HINCKLEY NATIONAL RAIL FREIGHT INTERCHANGE

Interim Stage 1 Road Safety Audit Response Report

Document reference: 21.1

Report Title:	Hinckley National Rail Freight Interchange – Interim Stage 1 RSA Response Report
Document Number:	HRF-BWB-HGN-RSA-RP-CH-0001
Prepared By:	BWB Consulting Ltd
Overseeing Organisation:	Leicestershire County Council
BWB Reference:	NTT2814

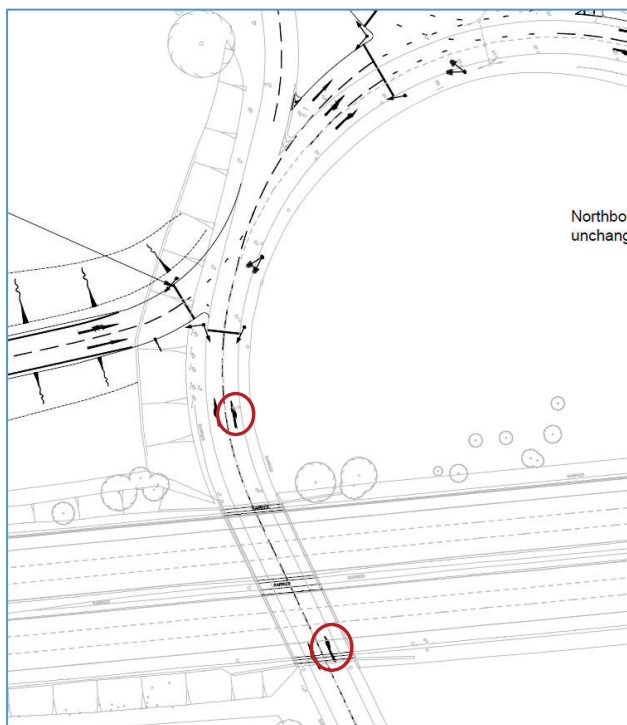
Around the southern carriageway of the circulatory the lane destinations show an “ahead” and a “right turn” arrow. However, approaching the junction and on the approaches before this point, “ahead” and “ahead and right” arrows are shown. This could lead to late lane changes, sudden and unexpected braking and side swipe type collisions due to driver confusion and late decision making as a result of confusing and misleading lane destinations.

RSA Ref.	RSA Problem and Recommendation	Design organisation response	Overseeing organisation response	Agreed RSA action
3.2	<p>Location: M69 J2 southern circulatory carriageway.</p> <p>Summary: Confusing road markings risk side swipe type collisions.</p> <p>Around the southern carriageway of the circulatory the lane destinations show an "ahead" and a "right turn" arrow. However, approaching the junction and on the approaches before this point, "ahead" and "ahead and right" arrows are shown. This could lead to late lane changes, sudden and unexpected braking and side swipe type collisions due to driver confusion and late decision making as a result of confusing and misleading lane destinations.</p> <p>Recommendation:</p> <p>It is recommended that the markings are amended so that they are consistent with the available movements around the southern half of the circulatory and on the westbound link road exit.</p>	<p>Agree with RSA Recommendation: Yes</p> <p>Road markings on the circulatory will be reviewed to ensure consistency.</p>

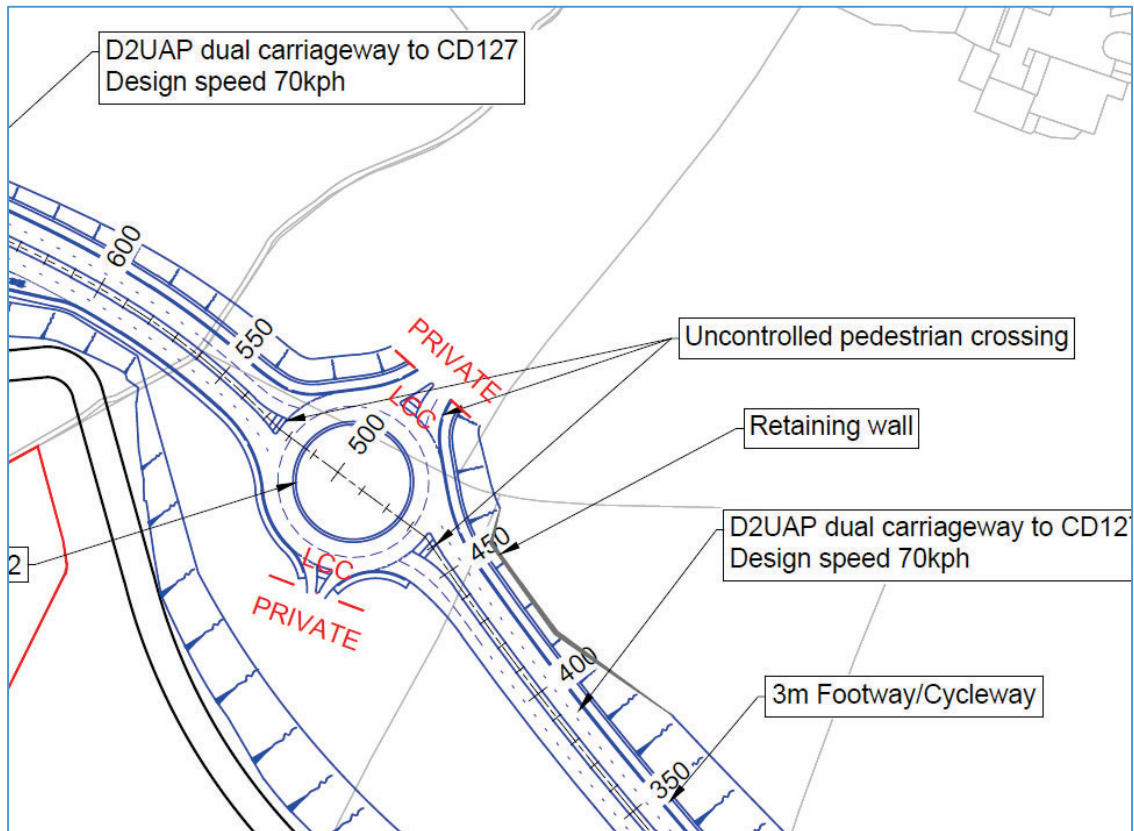
The existing bridleway crossing on the B4669 is set back from the carriageway by approximately 26m. Under the new arrangement equestrians will cross in front of the signal stop line, resulting in a diversion from the desire line and bringing riders towards the circulatory carriageway and traffic signals. There are concerns that the added noise and proximity to circulatory traffic may result in horses being 'spooked' and potentially result in vehicle to horse / equestrian collisions.

It is recommended that consultation is undertaken with local horse-riding groups and that, should the above concerns be realised, that the bridleway crossing is relocated.

RSA Ref.	RSA Problem and Recommendation	Design organisation response	Overseeing organisation response	Agreed RSA action
3.4	<p>Location: B4669 Hinckley Road approach to the M69 Junction 2.</p> <p>Summary: Bridleway crossing relocation risks vehicle to equestrian collisions. The existing bridleway crossing on the B4669 is set back from the carriageway by approximately 26m. Under the new arrangement equestrians will cross in front of the signal stop line, resulting in a diversion from the desire line and bringing riders towards the circulatory carriageway and traffic signals. There are concerns that the added noise and proximity to circulatory traffic may result in horses being 'spooked' and potentially result in vehicle to horse / equestrian collisions.</p> <p>Recommendation:</p> <p>It is recommended that consultation is undertaken with local horse-riding groups and that, should the above concerns be realised, that the bridleway crossing is relocated.</p>	<p>Agree with RSA recommendation: Yes</p> <p>Crossing point has been relocated further east to better sit on the desire line and shorten crossing distance.</p>

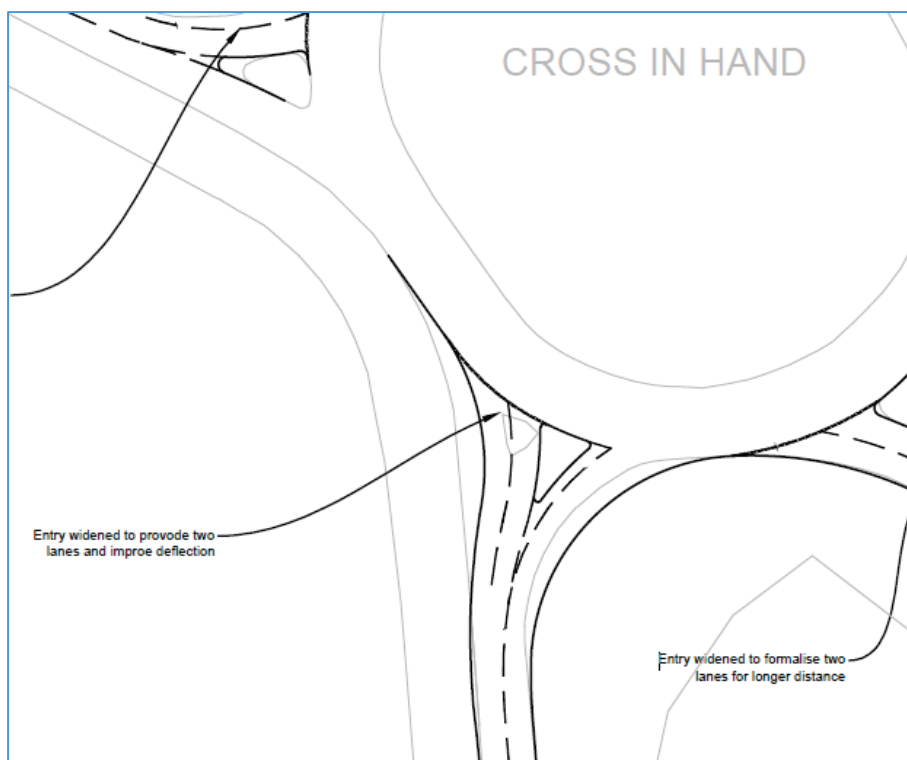
The proposed two-lane approaches appear to show lane widths of under 3.0m. Given the high-speed approaches and high percentage of HGV movements observed and expected through the junction, there is a risk that narrow lanes may result in side-swipe type collisions.

It is recommended that the lane widths are reviewed, and that localised widening is provided so that suitable lane widths can be provided.

RSA Ref.	RSA Problem and Recommendation	Design organisation response	Overseeing organisation response	Agreed RSA action
3.2	<p>Location: Coal Pit Lane, B4027 and A5 northbound approaches to the junction.</p> <p>Summary: Narrow lane widths risk side-swipe type collisions.</p> <p>The proposed two-lane approaches appear to show lane widths of under 3.0m. Given the high-speed approaches and high percentage of HGV movements observed and expected through the junction, there is a risk that narrow lanes may result in side-swipe type collisions.</p> <p>Recommendation:</p> <p>It is recommended that the lane widths are reviewed, and that localised widening is provided so that suitable lane widths can be provided</p>	<p>Agree with RSA Recommendation: No</p> <p>The lanes on the approaches to the roundabout flare from 1 to 2 lanes. The geometry here is in accordance with CD116 and the markings for the second lane commence as early as possible in accordance with para 6.1.3 of Traffic Signs Manual Chapter 5 which states: <i>'Where the carriageway is widened on the approach to a roundabout and extra lanes provided, drivers should be made aware of this by marking the lanes as early as possible. However, no lane should be less than 2 m wide at the start of the taper, or less than 3 m wide at the Give Way line (see Figure 6-1)'.</i></p>  <p style="text-align: center;">Figure 6-1 Conventional roundabout</p>

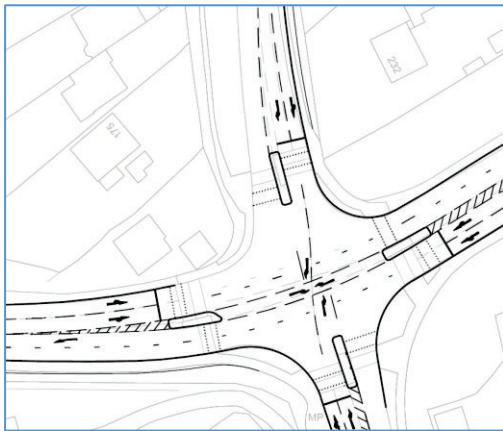
It was observed on site that a shared footway / cycleway is present along the southern side of the A47 through the junction. There is a concern that the proposed central island that segregates the two opposing traffic flows on this arm is not wide enough to safely accommodate shared use and there is therefore a risk of cycle to pedestrian collisions here.

It is recommended that the facility is amended to accommodate safe shared use.

RSA Ref.	RSA Problem and Recommendation	Design organisation response	Overseeing organisation response	Agreed RSA action
3.2	<p>Location: Ashby Road – southern arm o the junction.</p> <p>Summary: Narrow refuge for shared use risks cyclist to pedestrian collisions.</p> <p>It was observed on site that a shared footway / cycleway is present along the southern side of the A47 through the junction. There is a concern that the proposed central island that segregates the two opposing traffic flows on this arm is not wide enough to safely accommodate shared use and there is therefore a risk of cycle to pedestrian collisions here.</p> <p>Recommendation: It is recommended that the facility is amended to accommodate safe shared use.</p>	<p>Agree with RSA Recommendation: Yes</p> <p>The refuge has been widened to 3.5m to allow cyclists to use the staggered toucan crossing proposed.</p>

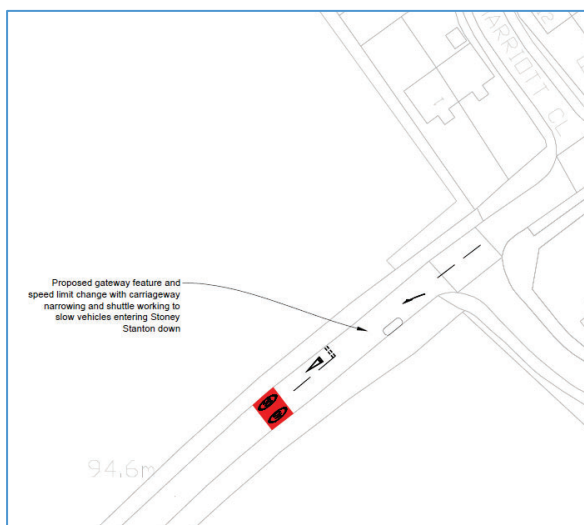
Whilst on site it was observed that there is a field access opposite the proposed feature on the northern side of Hinckley Road. It is unclear whether a farm vehicle (potentially with a trailer) would be able to turn in/out of the access without overrunning the feature, leading to it being damaged and potentially rendering it inconspicuous to other road users, risking kerb strikes and loss of control collisions.

It is recommended that a swept path analysis is undertaken using appropriate farm vehicles to assess whether they can access/egress the field access without overrunning the feature. If not, it is recommended that the arrangement is amended to accommodate the required movements.

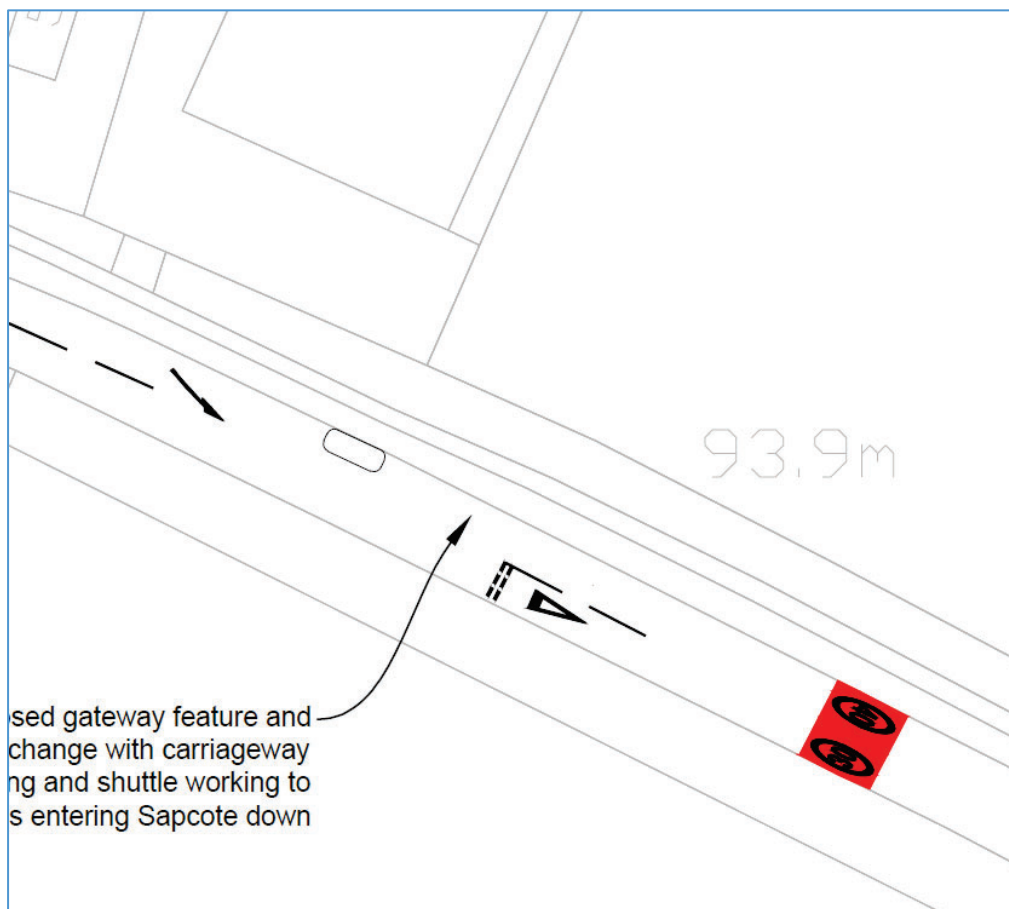
The footway immediately to the east of the proposed Zebra crossing is very narrow (<1m), with insufficient width for two-way pedestrian movements meaning pedestrians have to enter the carriageway in order to pass one another at a point where visibility of eastbound traffic is obscured by the adjacent property (refer to Problem 2). The location of the crossing will encourage an increase pedestrian movements along this narrow footway, risking vehicle to pedestrian collisions.

It is recommended that the crossing is relocated to a location where sufficient footway widths on the approaches are available.

RSA Ref.	RSA Problem and Recommendation	Design organisation response	Overseeing organisation response	Agreed RSA action
3.4	<p>Location: Leicester Road – footway to the east of the proposed Zebra crossing.</p> <p>Summary: Narrow footway risks vehicle to pedestrian collisions. The footway immediately to the east of the proposed Zebra crossing is very narrow (<1m), with insufficient width for two-way pedestrian movements meaning pedestrians have to enter the carriageway in order to pass one another at a point where visibility of eastbound traffic is obscured by the adjacent property (refer to Problem 2). The location of the crossing will encourage an increase pedestrian movements along this narrow footway, risking vehicle to pedestrian collisions Recommendation:</p> <p>Recommendation:</p> <p>It is recommended that the crossing is relocated to a location where sufficient footway widths on the approaches are available.</p>	<p>Agree with RSA recommendation: In Part</p> <p>The zebra crossing is a replacement for an existing uncontrolled crossing point and as a result additional pedestrians are unlikely to utilise the narrow section of footway. It is the opinion of the designer that a controlled crossing point makes it more likely that pedestrians will choose to cross the road to avoid using the narrow section of footway and as a result, the proposals reduce the safety risk posed by this existing section of footway. This said, the designer has revised the northern kerbline of the B4669 to provide a wider footway where possible and to enhance visibility to pedestrians crossing. Furthermore, the removal of the central islands on the B4669 means that large vehicles are less likely to mount the kerbs as they have the full width of the carriageway in which to manoeuvre rather than being restricted in width by refuge islands.</p>

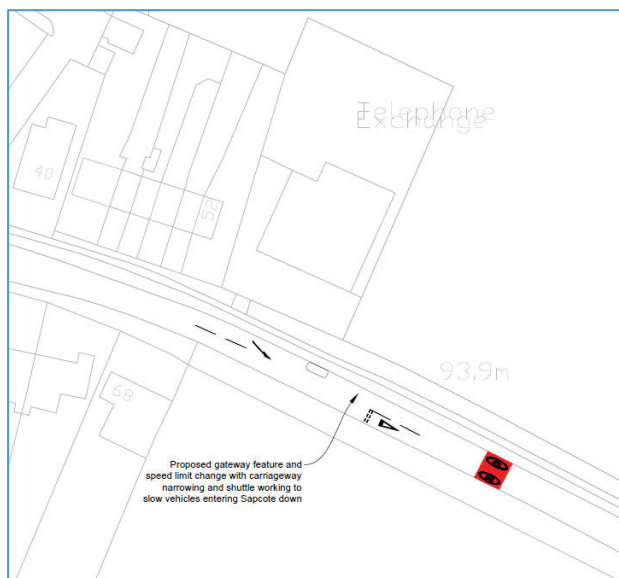
It is recommended that the feature is sufficiently illuminated during the hours of darkness.

3.5	<p>Location: Leicester Road - proposed traffic calming build-out.</p> <p>Summary: Lack of illumination risks collisions with the feature during the hours of darkness.</p> <p>There are no street lights close to the proposed traffic calming feature location and there are several mature trees in close proximity. This means that the feature may be inconspicuous during the hours of darkness, risking it being struck by eastbound vehicles resulting in loss of control incidents.</p> <p>Recommendation:</p> <p>It is recommended that the feature is sufficiently illuminated during the hours of darkness.</p>	<p>Agree with the RSA recommendation: Yes</p> <p>Further to discussions with the overseeing organisation, the gateway feature has been removed from the design.</p>

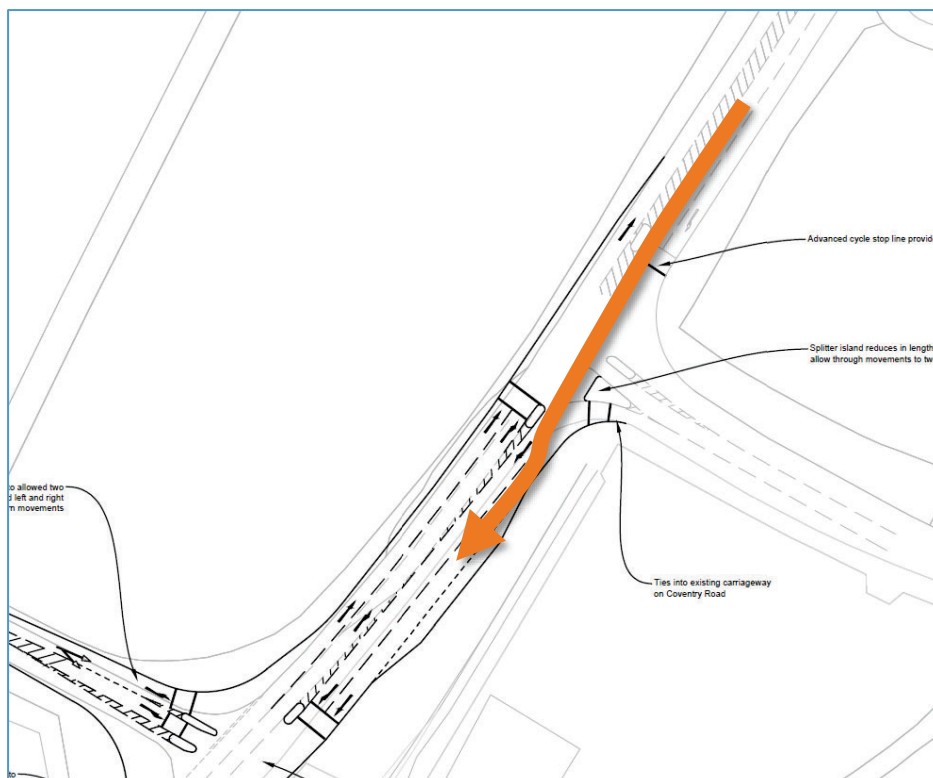
It is recommended that the signal and stop line arrangements are such that cyclists have a clear view of the traffic signals when waiting within the advanced stop line area.

RSA Ref.	RSA Problem and Recommendation	Design organisation response	Overseeing organisation response	Agreed RSA action
	<p>Location: Existing signalised junction of the B4114 and B581 Coventry Road.</p> <p>Summary: Location of new advanced stop lines limits traffic signal visibility and risks vehicle to cycle shunts / collisions. The proposed advanced stop line waiting areas on the northern and eastern arms of the junction are in advance of the majority of the traffic signals within the junction. Should signal visibility be restricted there is a risk that following motorists will move off prior to cyclists getting underway, risking collisions between the two .</p> <p>Recommendation:</p> <p>It is recommended that the signal and stop line arrangements are such that cyclists have a clear view of the traffic signals when waiting within the advanced stop line area.</p>	<p>Agree with RSA recommendation: Yes</p> <p>Locations of advanced stop lines will be reviewed and amended where required.</p>
